## PRE-APPLICATION CONFERENCE NOTES

YMCA Site Plan  
 File No. PLZ-22-0146

<b>Issued</b>	January 24, 2023

Figure 3. Pre-app site plan

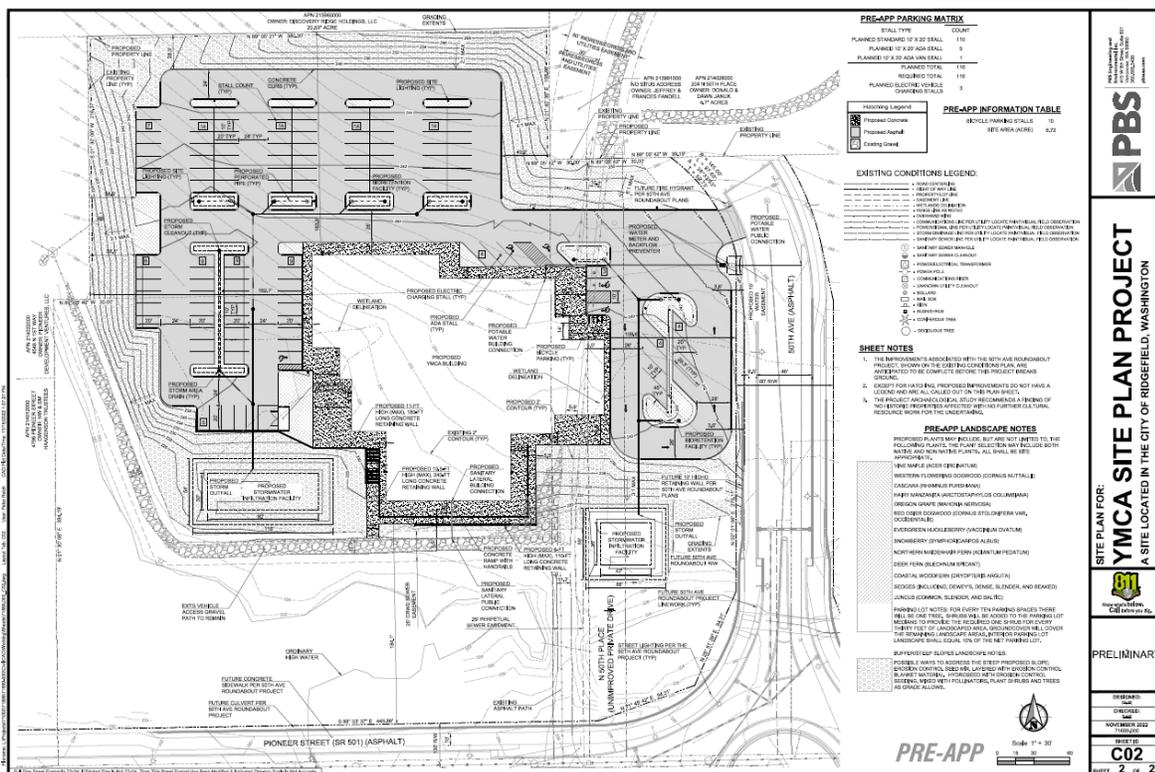
The proposal is to construct a 46,400-square foot (two stories) YMCA facility with associated parking, utilities, and landscaping. The YMCA building is designed to include two pools, a gymnasium, a fitness area, physical therapy room, and community room. Outside of the building, a trail is proposed across the site stubbing to the neighboring property to the northwest. Access to the site is proposed from future N 51<sup>st</sup> Place, which will extend north from a future roundabout on Pioneer Street/SR 501.

**Boundary line adjustment.** Buildings may not cross lot lines. As proposed, the YMCA building would be located on APNs 213961000 (as adjusted through PLZ-22-0101), 986044069, and 214028000. A boundary line adjustment (BLA) will be required to transfer the southern flagpole portion of APN 214028000 to APN 986044069 or 214026000. Then, a BLA would be required to consolidate the resulting adjusted parcels on which the YMCA building is to be located. The two adjustments may be processed through one BLA application if the project timing permits.

- Outdoor common areas.
  - Outdoor common areas equal to five percent of the gross floor area are required. As proposed, the minimum outdoor common area required is 2,320 square feet. The minimum size for a common area is two hundred fifty square feet. Fewer, larger common areas are preferred over multiple, smaller common areas.

- Common areas must be developed per RDC 18.230.050.F.
  - Staff requests detail in the project narrative regarding how YMCA programming may be integrated into outdoor common areas, and how the proposed trail accesses the eastern site entry.
